MONTERRA COMMONS

DESIGN GUIDELINES

MONTERRA, PARCEL C-2

Exhibit 2a : PMUD Master Plan

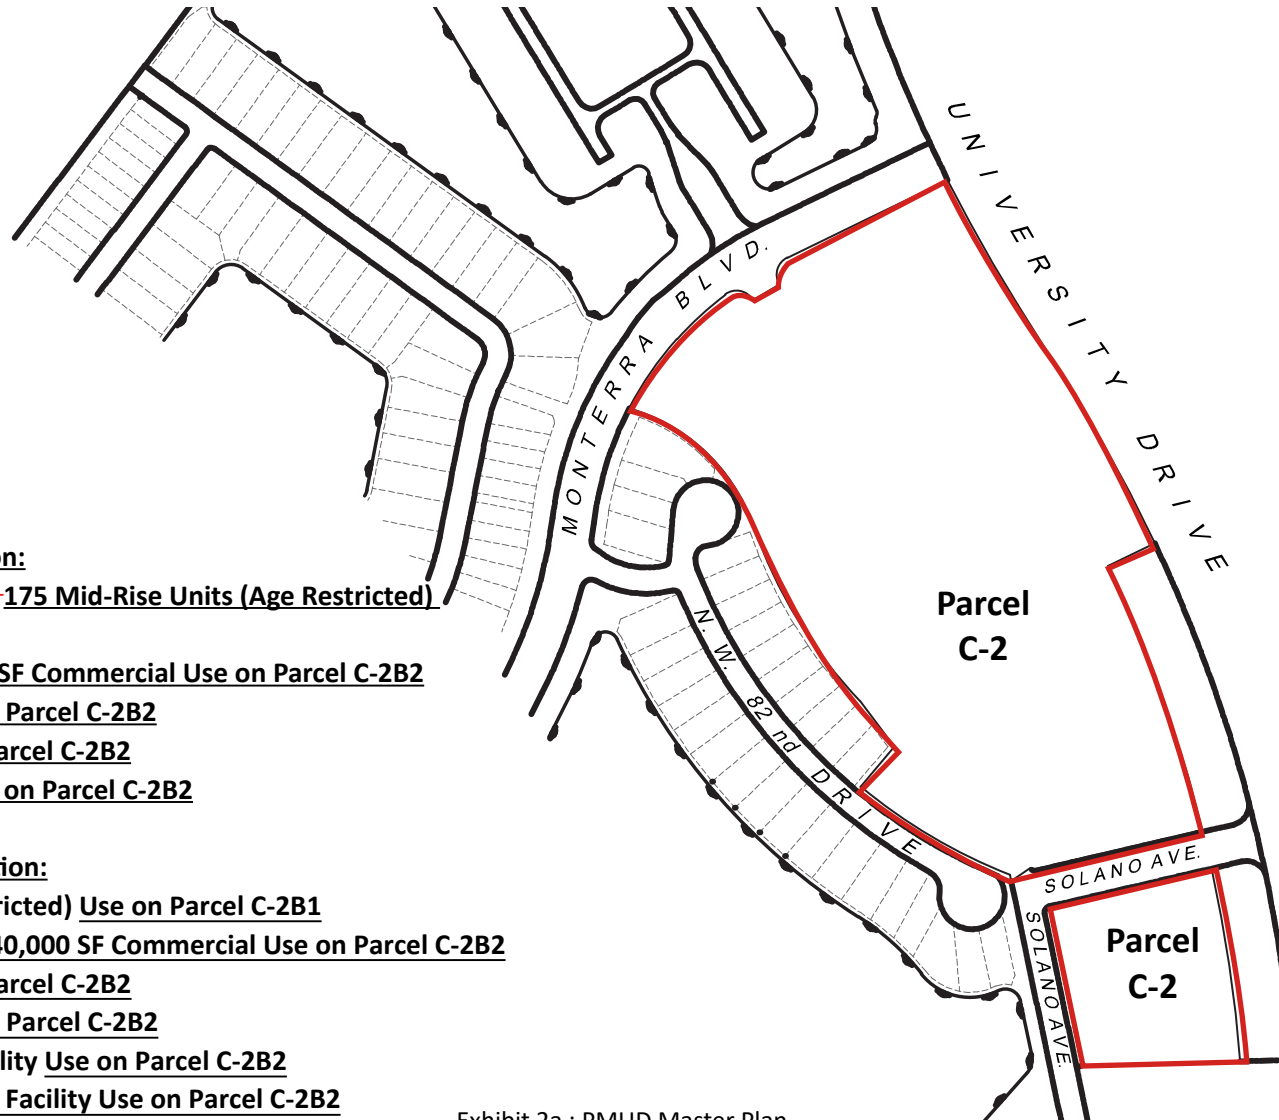
- ~~160,150 SF Commercial~~ 175 Mid-Rise Units (Age Restricted) on Parcel C-2B1
- ~~70,000 sf Office~~ 73,500 SF Commercial Use on Parcel C-2B2
- 63,800 SF Office Use on Parcel C-2B2
- 6,200 SF Bank Use on Parcel C-2B2
- 10,000 SF Day Care Use on Parcel C-2B2

- 175 Mid Rise (Age Restricted) Use on Parcel C-2B1
- ~~73,500 SF Commercial~~ 40,000 SF Commercial Use on Parcel C-2B2
- 6,200 SF Bank Use on Parcel C-2B2
- 63,800 SF Office Use on Parcel C-2B2
- 10,000 SF Day Care Facility Use on Parcel C-2B2
- 116,000 SF Self-Storage Facility Use on Parcel C-2B2

c. EXHIBIT 4c - Parcel C-2 Sign Types

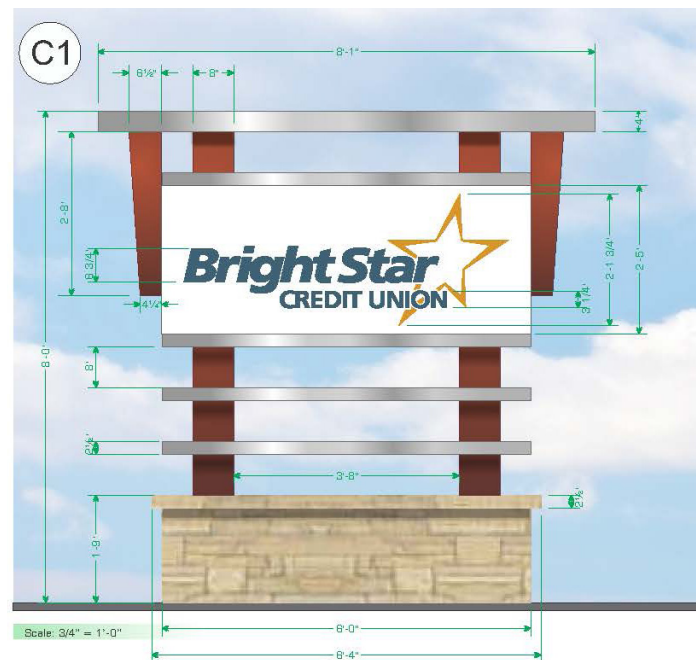
- **Type A sign** -Proposed: 17'-4" wide x 18' tall Monument Sign. Sign may be double -faced with a maximum 110 SF sign area per sign face. The square footage of the sign is increased by 229% to achieve the intended design.

- 2 sign is permitted and 5 are proposed
- Max sign area of 48 SF is permitted and 110 SF is proposed
- Maximum height of 8' is permitted and 18' is proposed
- Maximum height of letters permitted is 23" and 13" is proposed
- Maximum 0 tenant panel are permitted and 10 tenant panels are proposed

c. EXHIBIT 4c - Parcel C-2 Sign Types continued...

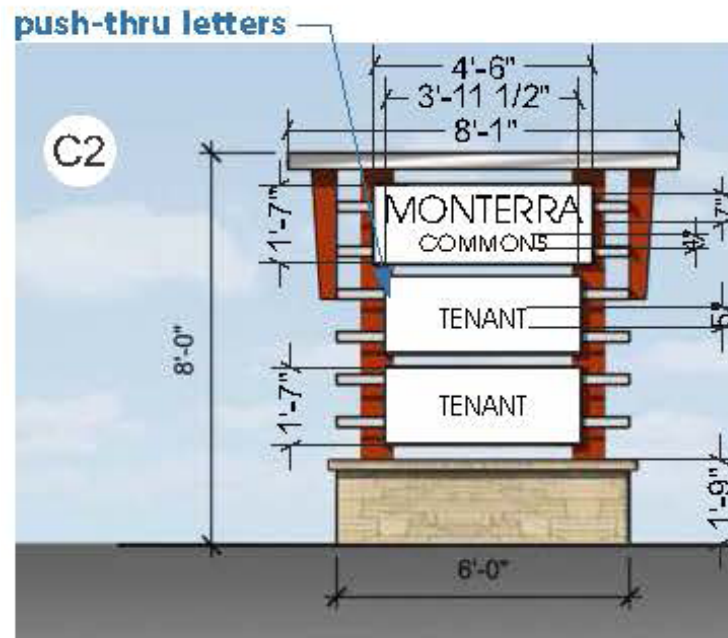
- **Type C-1** sign - Proposed: 6' wide x 8' tall Monument Sign. The two Type C-1 signs will be an identification sign for the office building and the self-storage facility. Sign may be double-faced with a maximum 25 SF sign area per sign face. The square footage of the sign is increased by 138% to achieve the intended design.

- 2 sign is permitted and 5 are proposed
- Max sign area of 18 SF is permitted and 25 SF is proposed
- Maximum height of 8' is permitted and 8' is proposed
- Maximum height of letters permitted is 14" and 27" is proposed
- Maximum 1 tenant panel is permitted and 1 tenant panel is proposed
